PRELIMINARY OVERALL AREA DEVELOPMENT PLAN

OAK CREST SUBDIVISION POADD		M.W. CUDE & ASSOCIATES, INC. CONSULTING ENGINEERS (210) 681-2351		DATE	DESCRIPTION
#118B		WAILING ADDRESS: P.O. BOX 70009 SAN ANTONIO, TEXAS 78270		LOCATION: 1525 BANDERA RD. SAN ANTONIO, TEXAS 78250	
DRAWN BY:	E.C.	DATE:	JULY 1997	SHEET 1 OF 1	
CHECKED BY:	SLV	JOB NO.:	148000-08

POADP # 118 - B

REQUEST FOR REVIEW

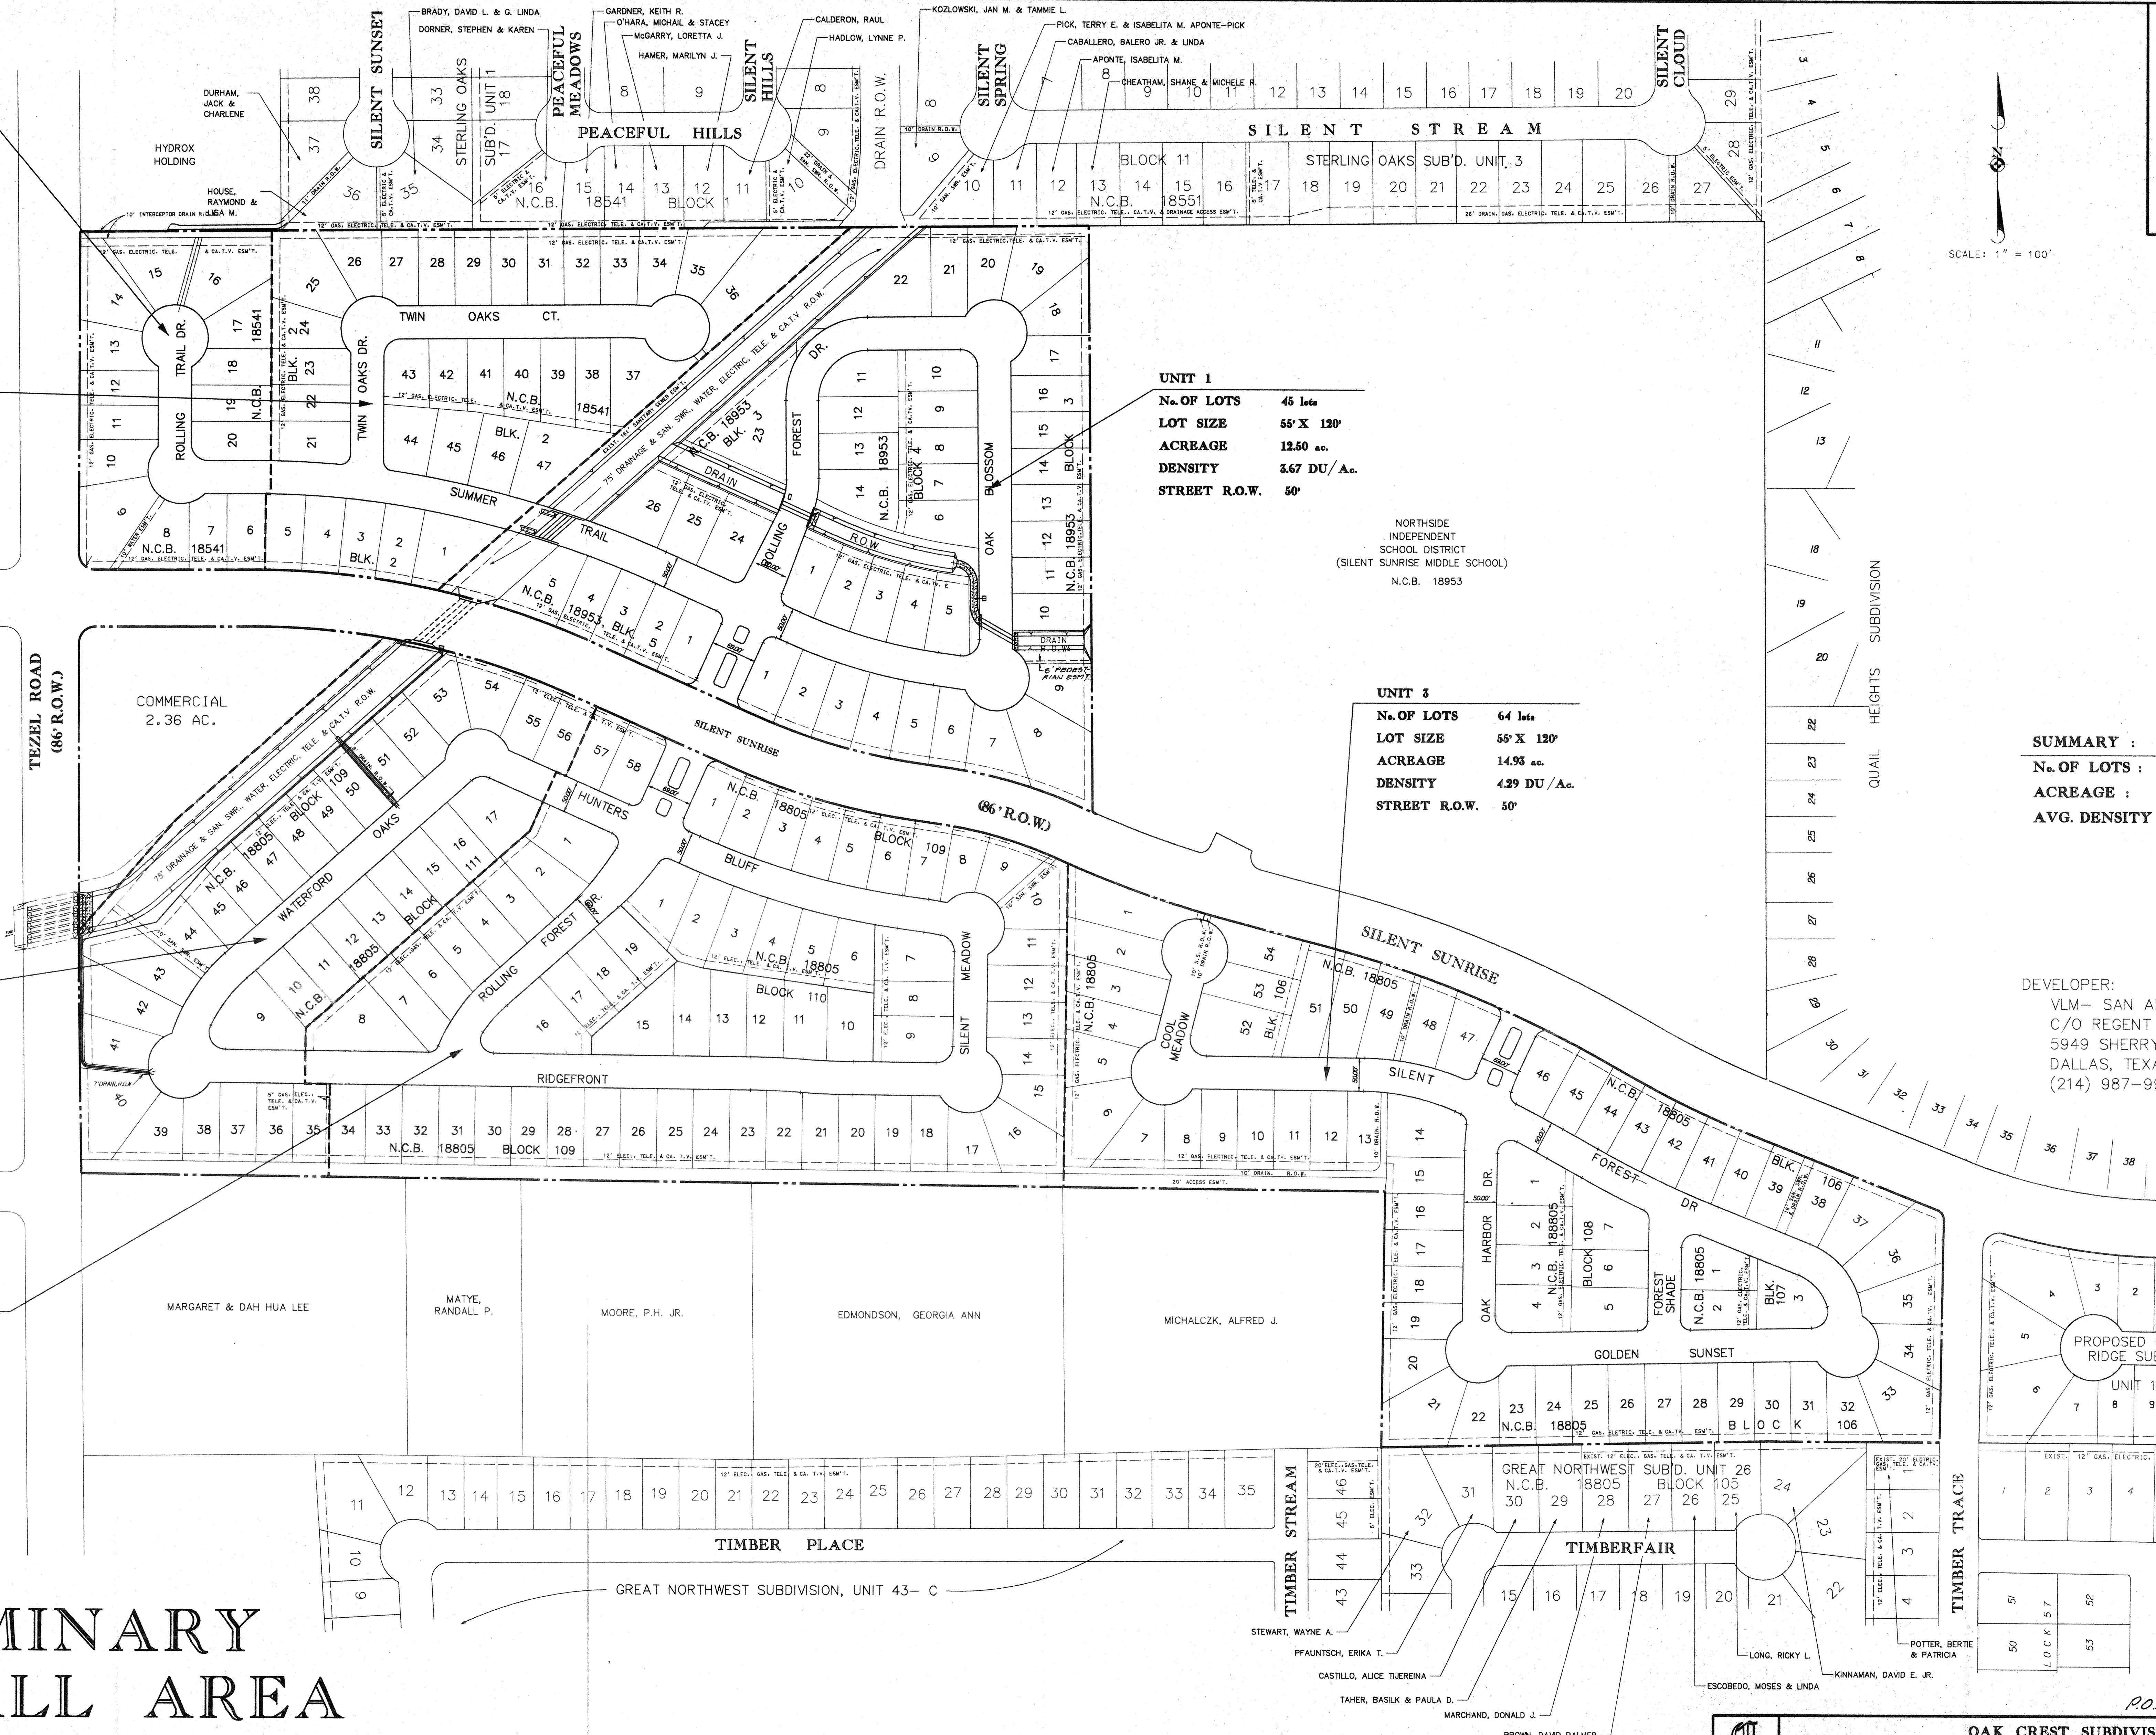
- Based on the topography, a Flood Plain Study and drainage review will probably be required during the platting process.
- This development will need to comply with tree preservation ordinance #85262. For additional information about these requirements you can contact Building Inspections at 207-7102.

Drainage Easements will be required and
address during the platting process.
